Birriwa Solar and Battery Project

Modification Submissions Report

Prepared for ACEN Australia Pty Ltd

December 2025

Birriwa Solar and Battery Project - Modification Submissions Report
Figure 3.1

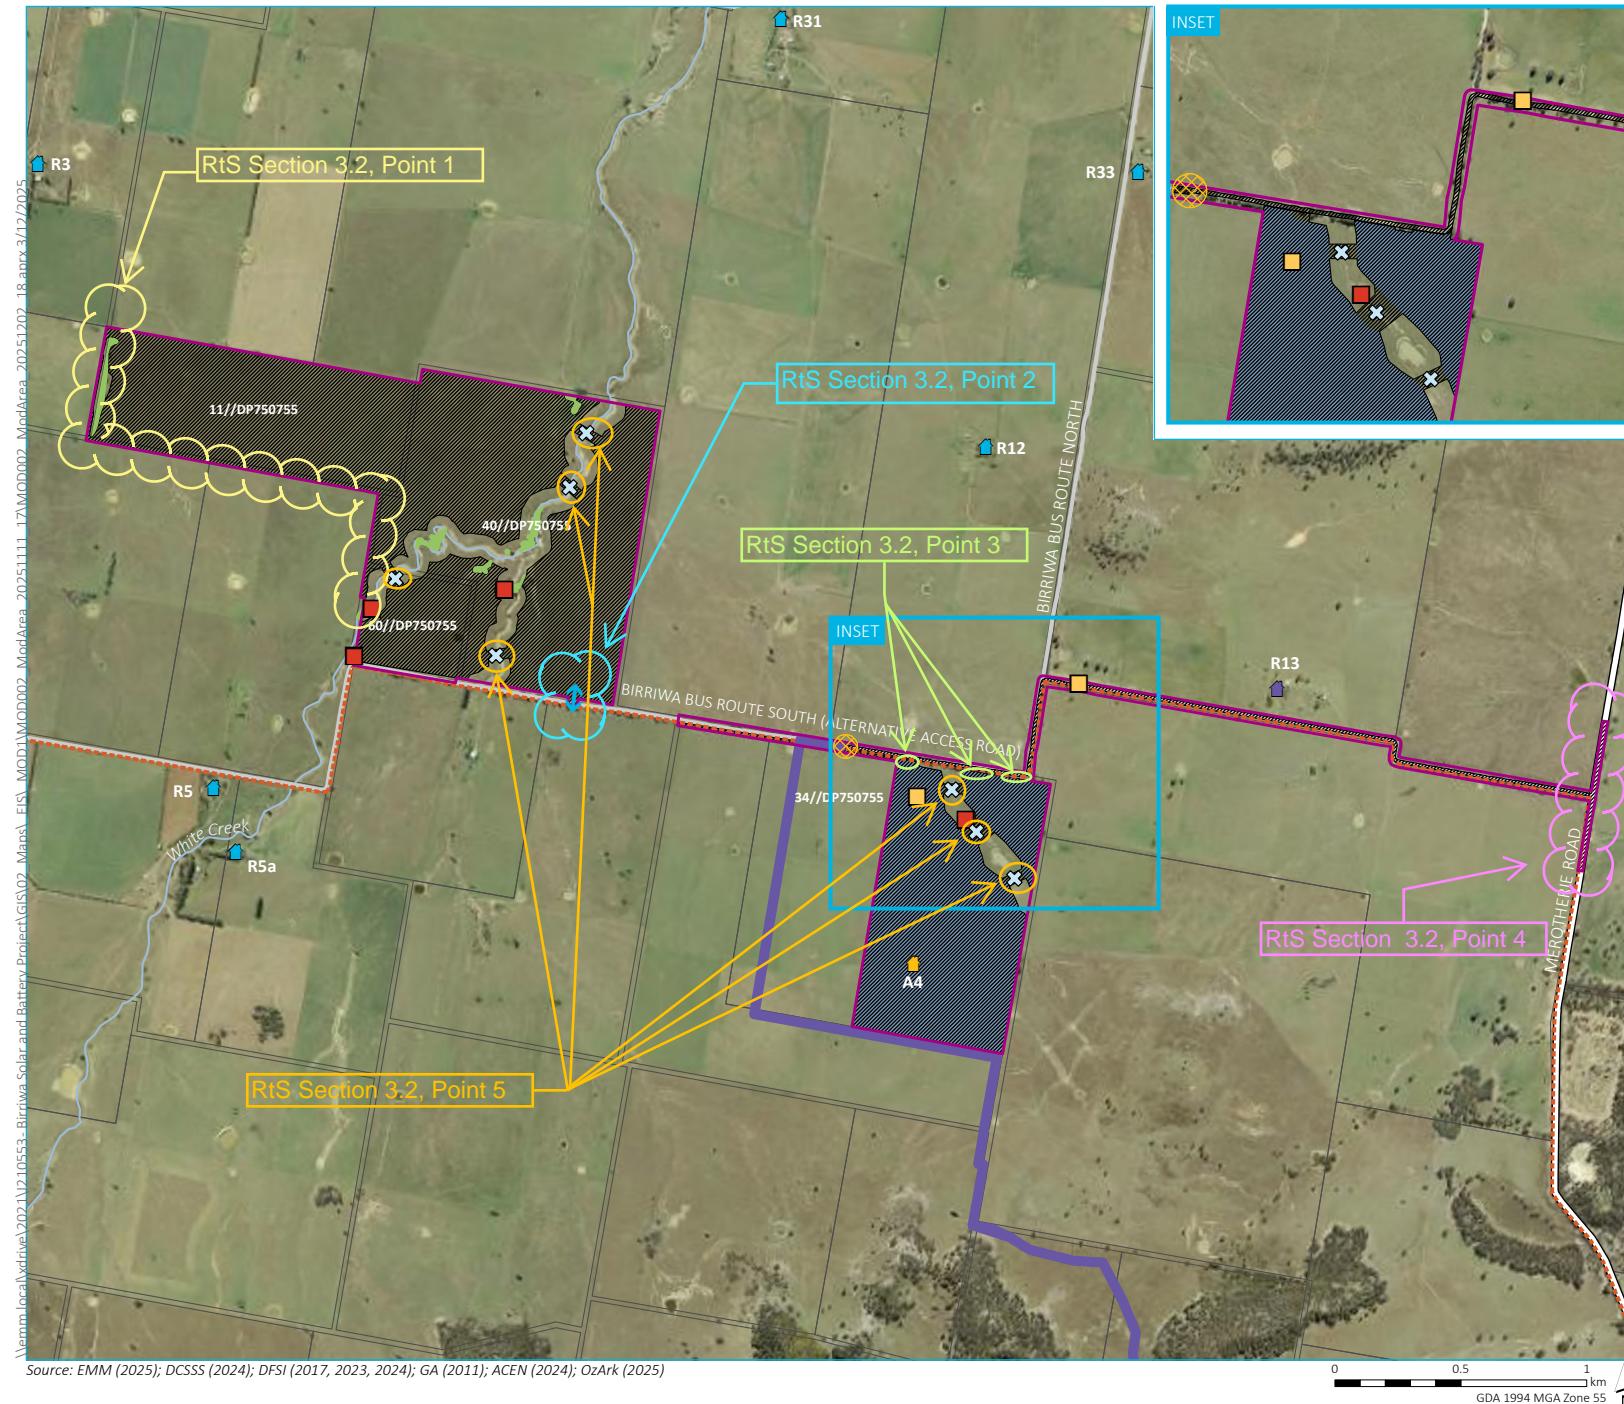
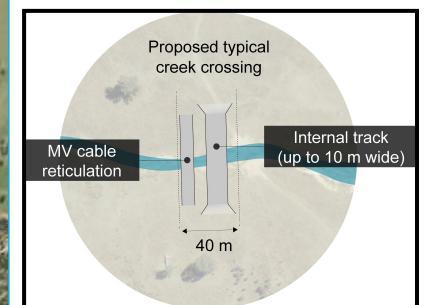
The Biodiversity Development Assessment Report (BDAR) has been revised in response to advice received within CPHR's submission, and is included in Appendix E. Following the revision of the BDAR, minor adjustments to the modification development footprint and modification area have been reflected across all BDAR figures and the figures within this report including Figure 1.2 (modification area). The changes include (refer to Figure 3.1):

i Merotherie Road/BBRS intersection

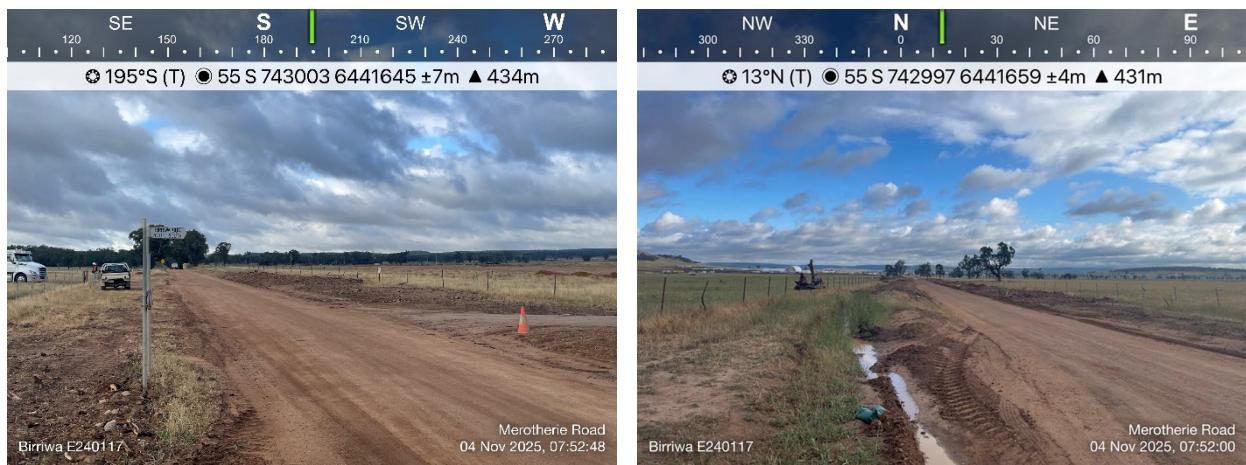
CPHR are unable to confirm whether the BAM has been applied to the entire area being directly impacted by the modification. Additional direct impact areas are suggested within the Modification Report and Appendix H (Traffic Impact Assessment), outside the development footprint depicted within the BDAR. Some impacts are indicated for areas stated to be avoided.

The site distances on Merotherie Road from BBRS have been estimated based on the line of sight, as shown in Figure 6.4 of the TIA. Based on the sight distance analysis, a number of mature trees may require removal on the western side of Merotherie Road as circled in Figure 6.4 of the TIA, as per the final design to the satisfaction of Mid-Western Regional Council.
